Surveillance Report

Package / Item:	Bascule span to the Railway bridge "Jernbanebroen over Limfjorden"
Supplier:	MT Højgaard
Purpose of visit:	Production & Quality Surveillance – Steel structure Visit No. 2
Location / Address:	Tarcon Tarnobrzeg Poland

Date of Visit / Review: 2012-08-14

Welder number S26 signature made with a pen marker.

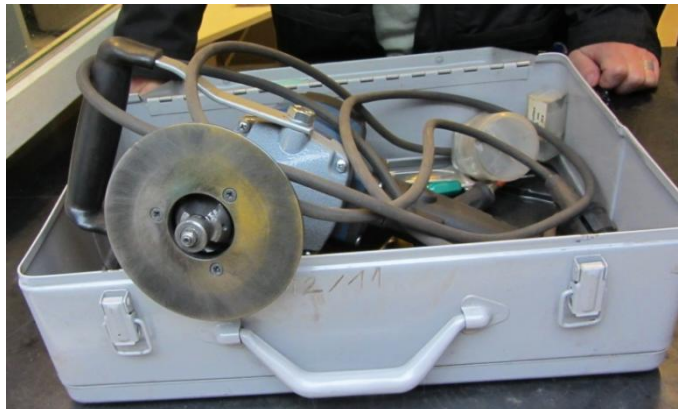
Tarcon informed Rambøll, what pen markers were/are used for welder's signature on the steel surfaces. Based on a trial test in the shop, Rambøll found that only pen markers were used, and a logbook with notes about which welds each welders had produced were shown. Rambøll was informed that welders ID additionally will be noted on the production drawings. Rambøll has no comments.

Rambøll was informed that scrapped elements and the replacement had the same tags. Rambøll found it a problem that there is no difference between scrapped elements and new elements, Rambøll cannot see how to distinguish between which elements that have been checked at the end documentation – checked element can be the ones that are scrapped. A procedure is needed to ensure that new replacement elements get the right quality control.

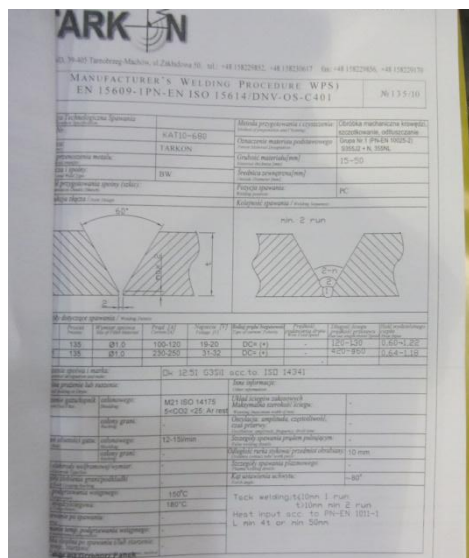
- WPS no. KAT 10-707 is verified according to DnV. This differs to the required EN 15614. Tarcon shall perform a deviation report.
- The welding engineer showed a WPS for butt welds in 50 mm plates with a preheating of 150 degrees celcius. The welding engineer informed Rambøll that butt welds in 20-40 mm plates will be performed with preheating of approximately 75 degrees Celsius. A WPS for this type of welding was missing. Tarcon shall forward an additional WPS for butt welds in 20-40 mm plates.
- On WPS no. 87/09 and no. 24/09, shall the travel speed, heat input and allowable wearing (maximum width of run) to be stated. This shall be according to the WPQR. This comment governs for all WPS where relevant.

Rambøll haven't received the required documents before the second visit and only the demanded deviation rapport was received at the visit. After the visit Rambøll has the following question to the deviation rapport; is it correct that the HV differs a lot from EN 15614 tabel 2?

At the inspection Rambøll asked the welding engineer about WPS number 135 with focus on the preheat temperature (this WPS was present in the project specified folder at the shop floor). The welding engineer informed that they for plates with thickness around 50 mm preheat as stated on the WPS, but for smaller plates they lowered the preheat temperature. Rambøll find it concerning that the welding engineer told that they doesn't follow the WPS correctly, because then the coherent WPQR isn't valid. Rambøll find it necessary that Tarcon find out where they have used this WPS and if they have used it with a lower preheat then stated on the WPS some additional tests may be needed.

Rambøll also find that a preheat of 150 degrees of celsius is high for plates with a thickness between 20-40 mm, therefore as required after the first visit an additional WPS shall be used and forwarded to Rambøll.
